Subject: **Request for Modification to the Section 404 Individual Permit and Section 401 Water Quality Certification and Application for Jordan Lake Riparian Buffer Certification** for the proposed Greensboro Eastern Loop from US 70 Relocation to SR 2303 (Lawndale Drive), Guilford County, Division 7. WBS Element No. 34821.1.1, TIP Nos. U-2525B and U-2525C.

**Subject:** Minutes of the Interagency Hydraulic Design Review (4b) Meeting on November 12, 2015 for U-2525C, Guilford County

**Subject:** Final Minutes of the Interagency Permit Drawings Review (4C)  
Meeting on October 19, 2016 for U-2525C in Guilford County

TIP PROJECT: U-2525C

# D

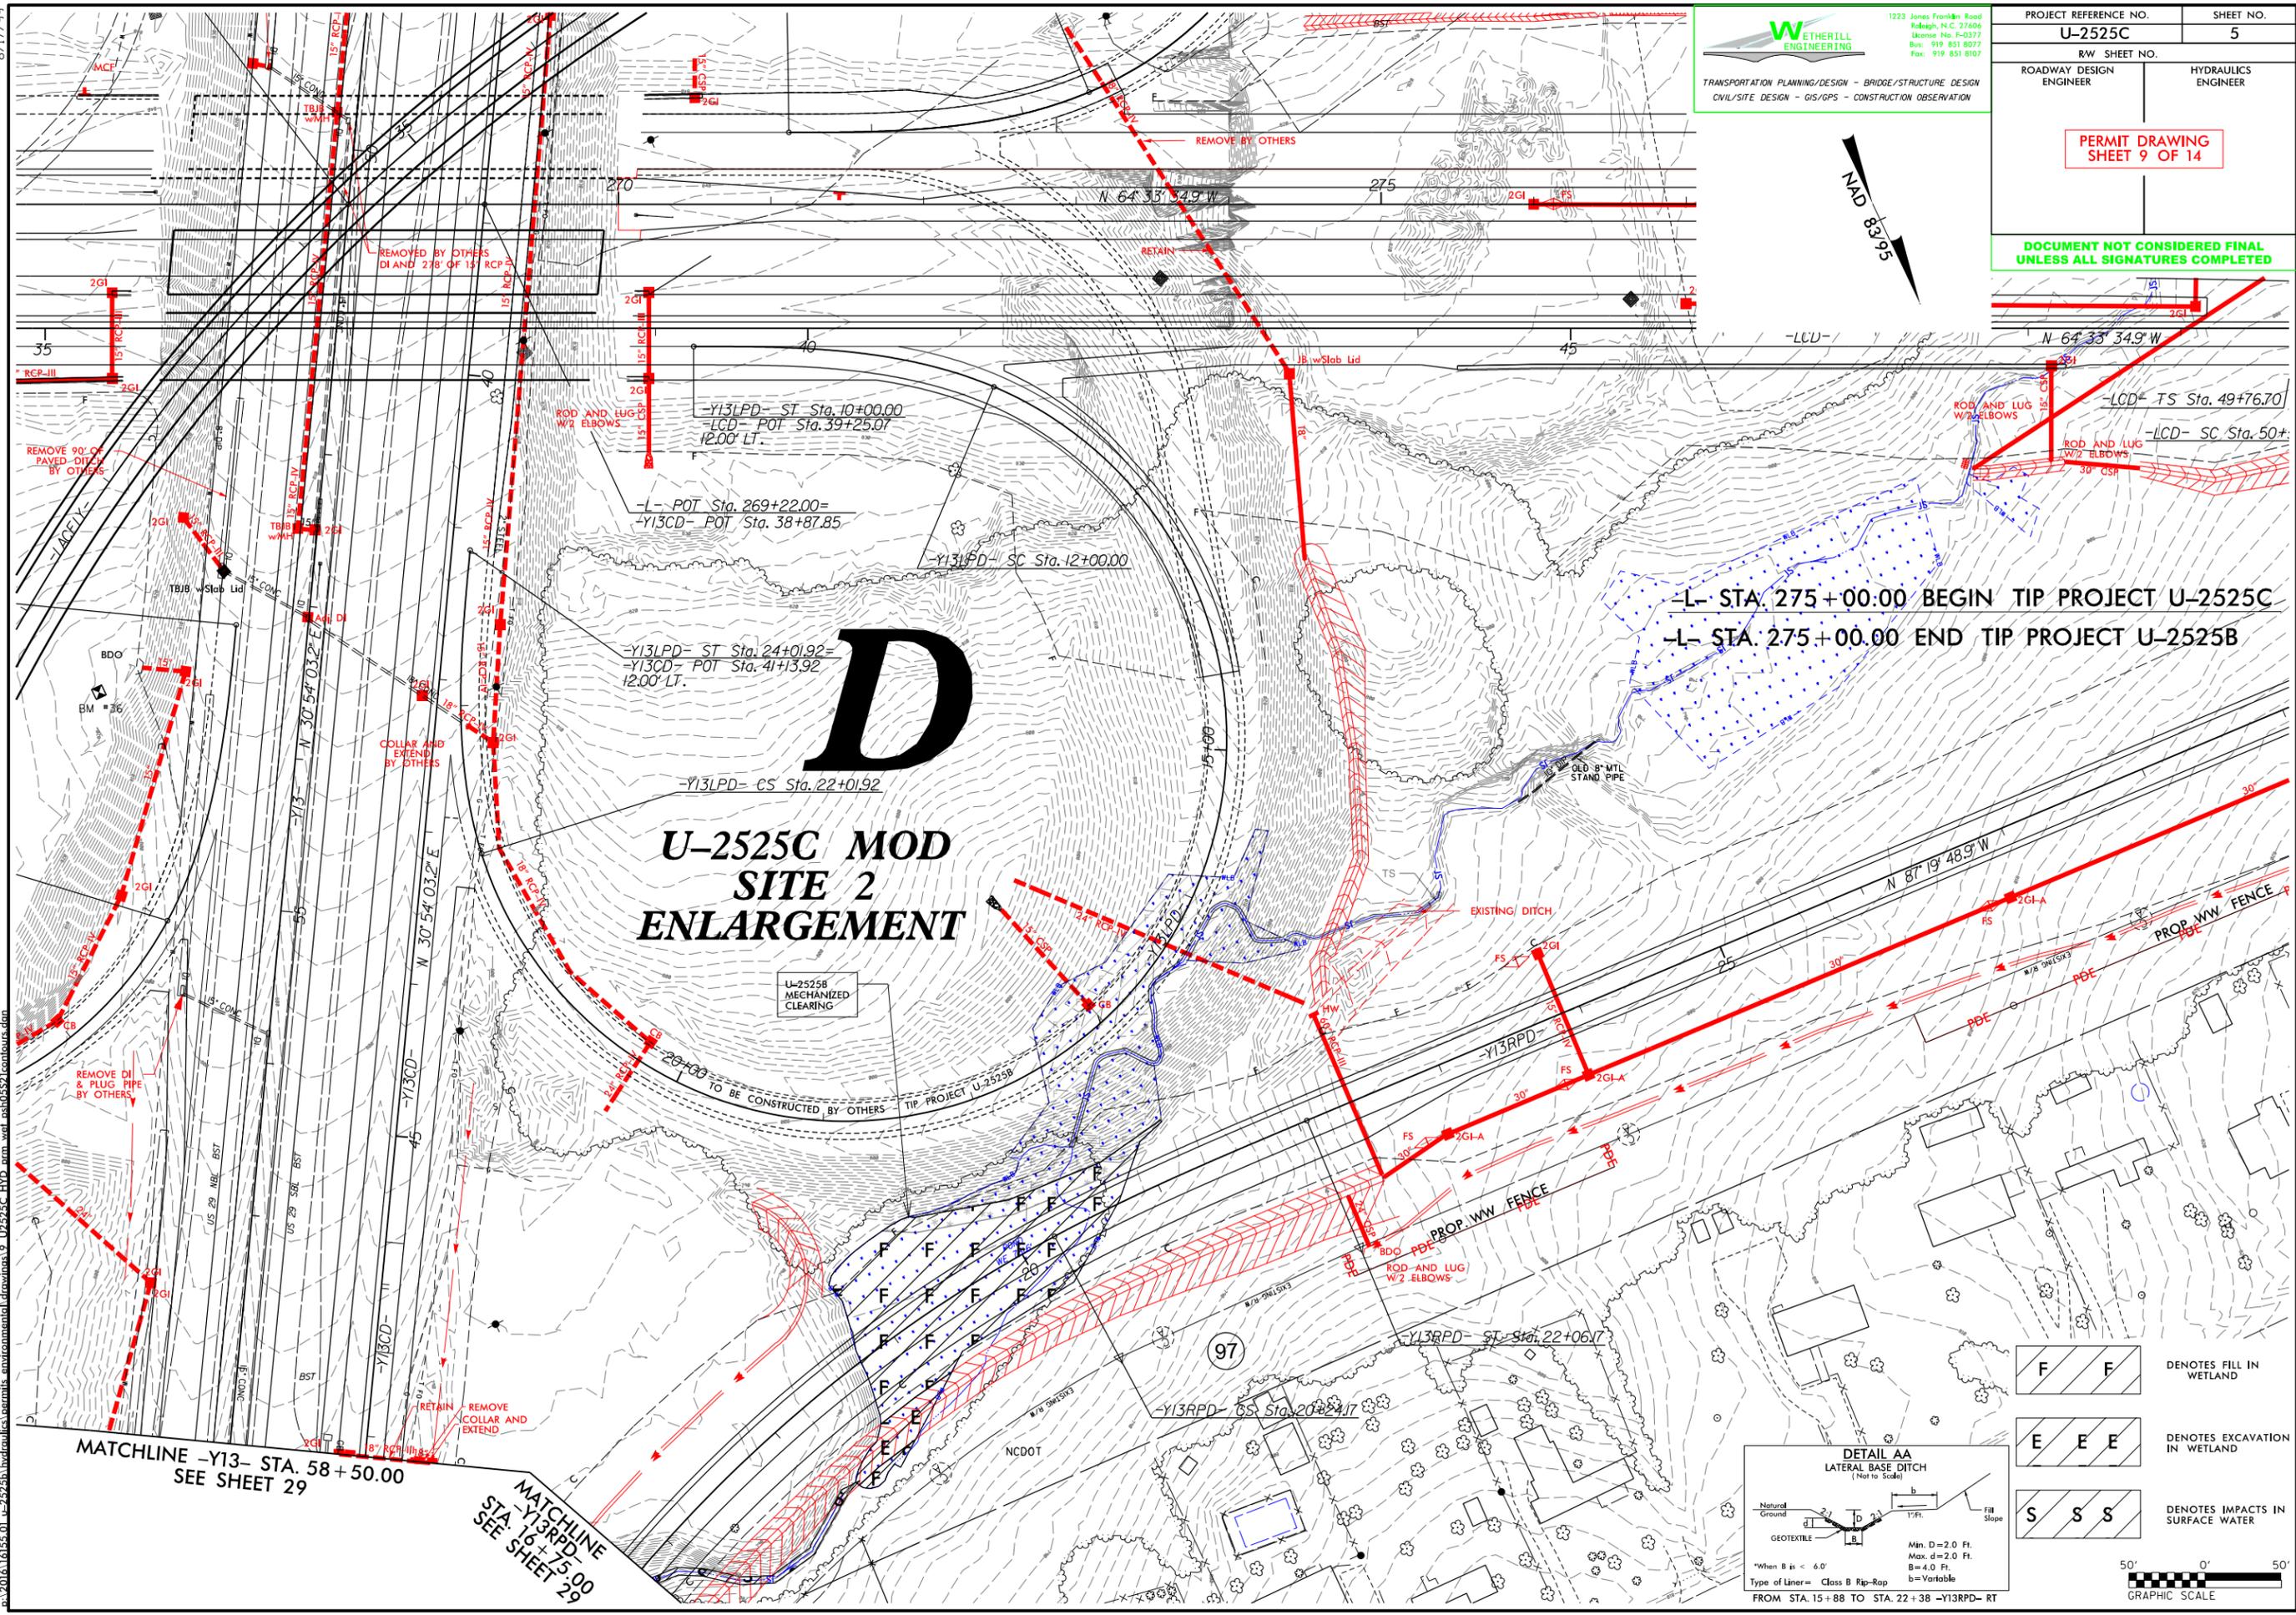
Site 2 was shown in the preliminary drawings for U2525C and overlaps in the mechanized clearing of Site 21 under U2525B. The impacts under U2525B are grayscale on Wetland and Surface Water Impacts Permit Drawing Sheets 6 through 9.

Notice that the wetland that is within the gore area left of station –Y13LPD- 14+50 and left of station –Y13RPD- 26+00 is not proposed to be disturbed. The existing steep topography is not affected by the design. The site can be further discussed with the modification for U-2525C Site 4.

# U-2525C MOD SITE 3 ENLARGEMENT

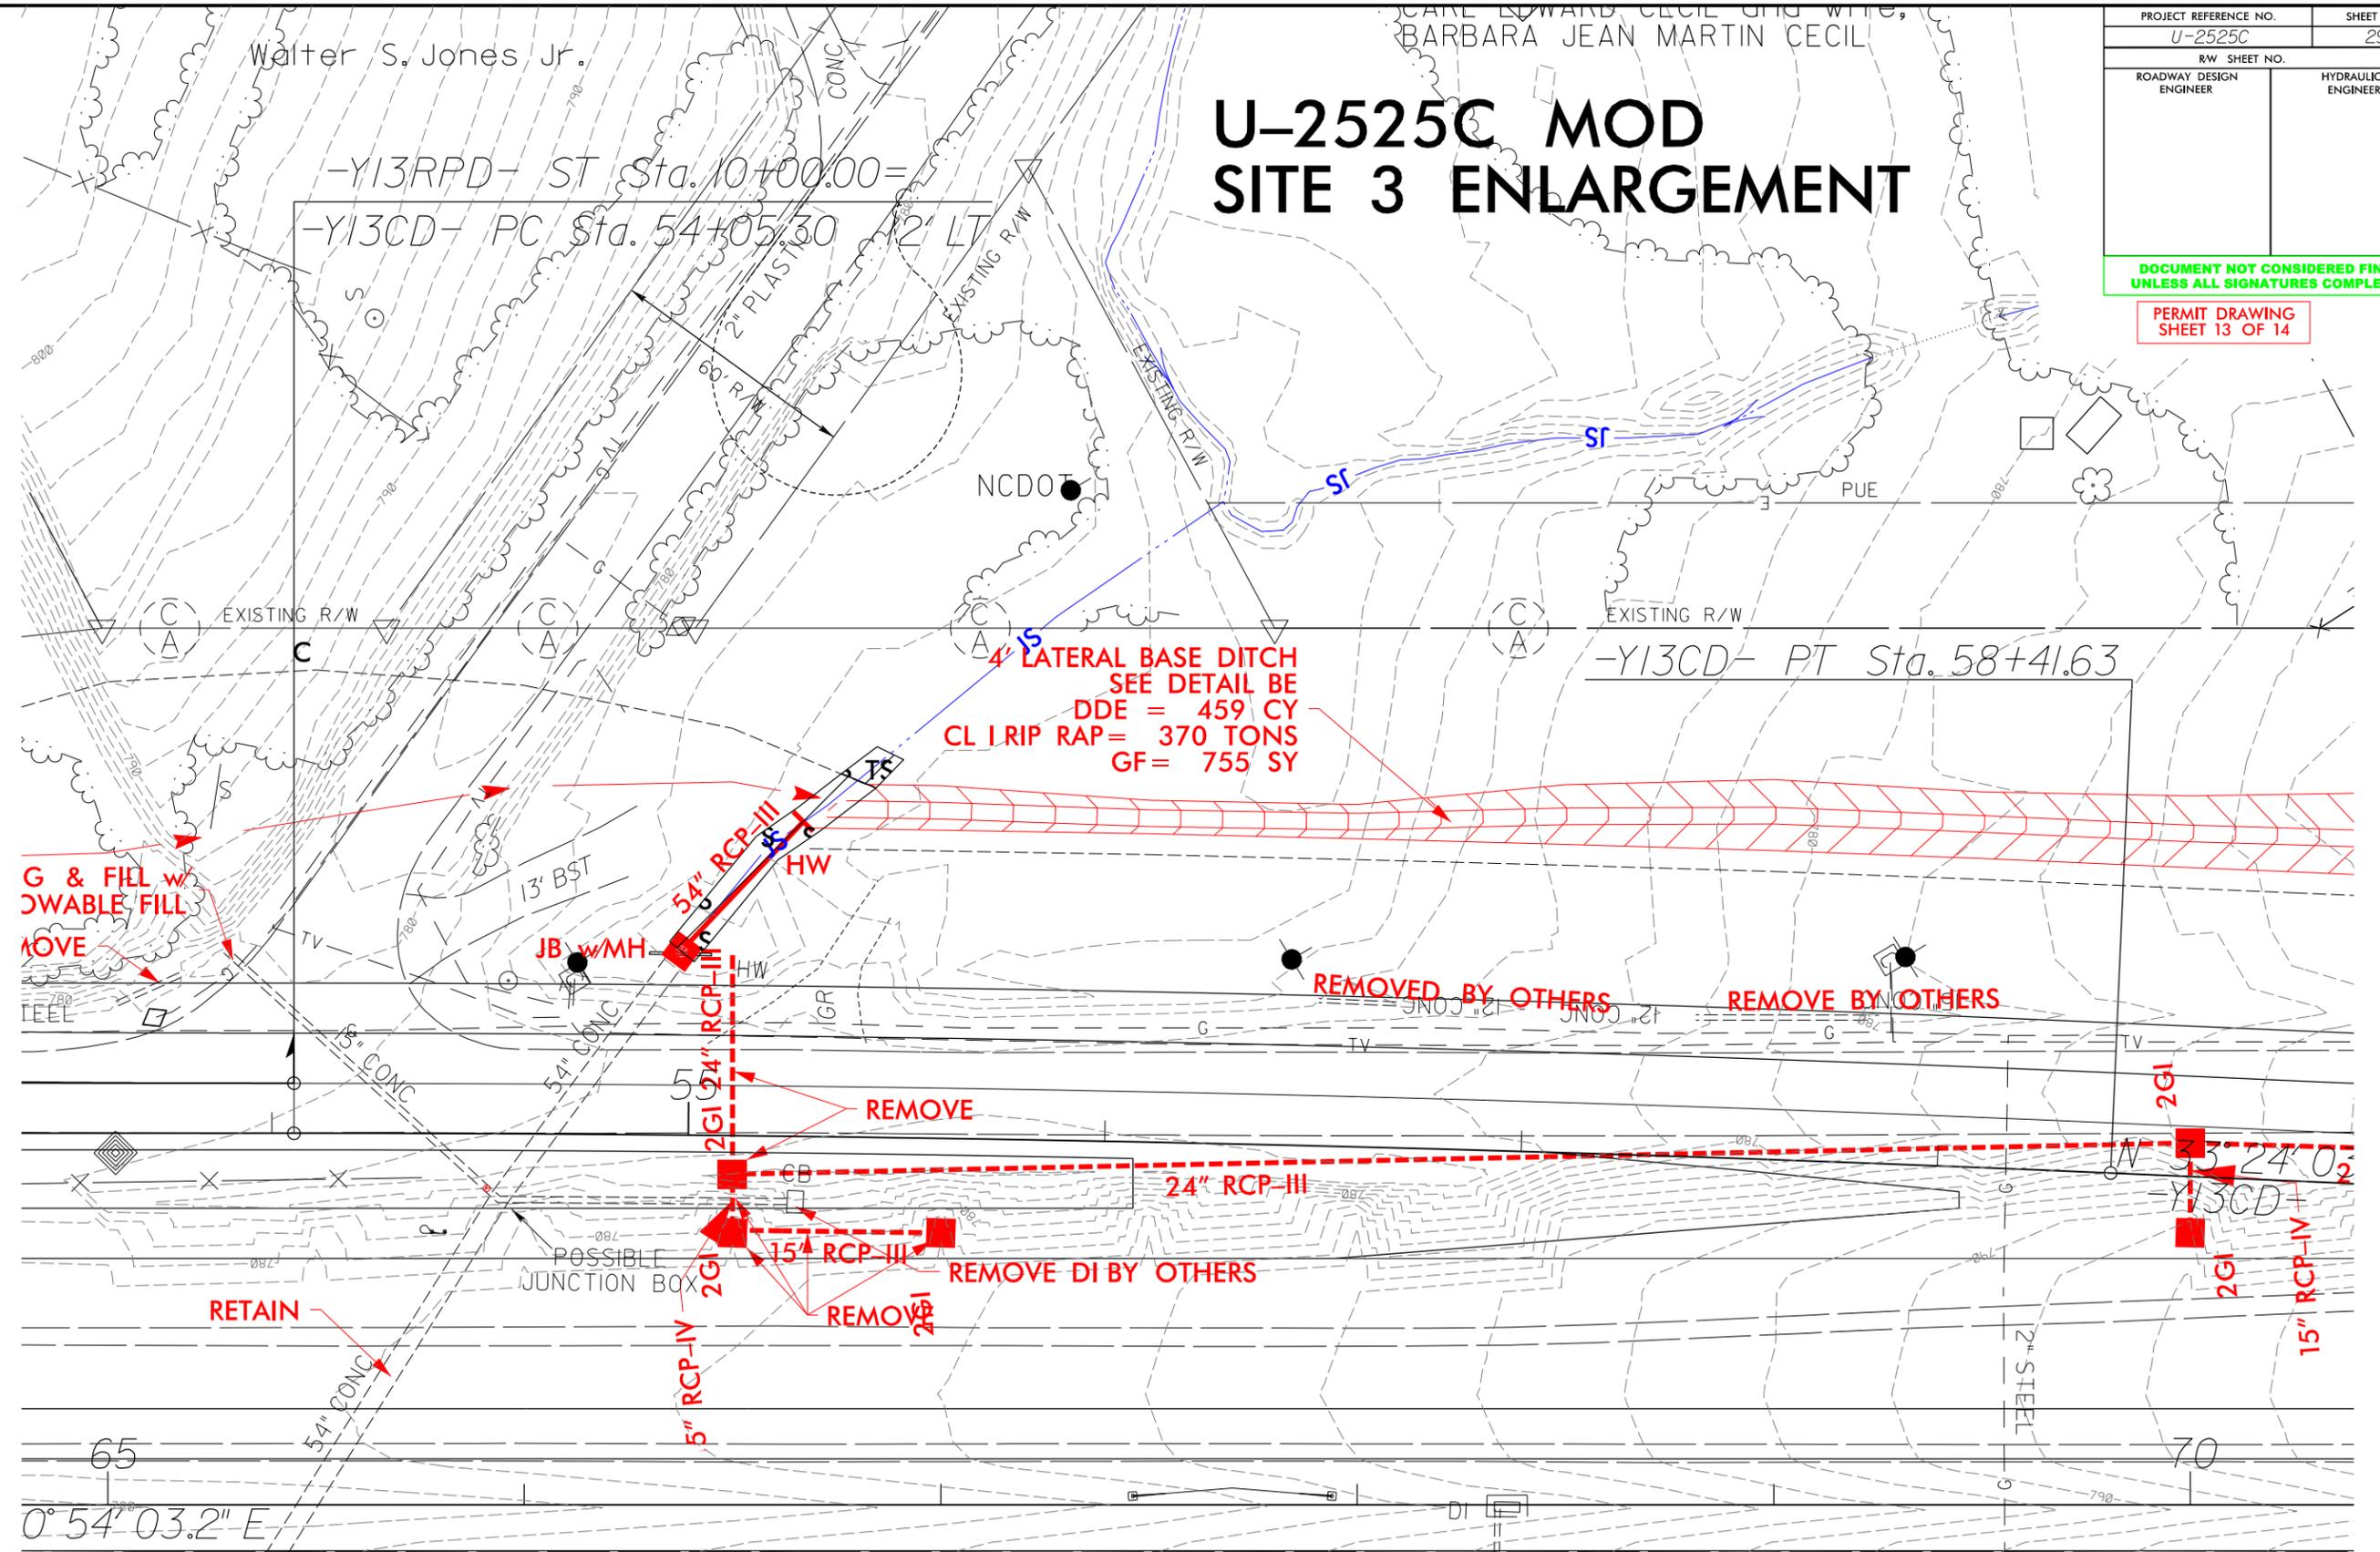
Site 3 was not included on the U-2525B project. U-2525C builds –Y13CD- and extends the existing 54” RCP upstream and created surface water impacts.

The depicted bank stabilization should be shown on a separate line in the summary sheet as permanent impacts and not as temporary impacts.
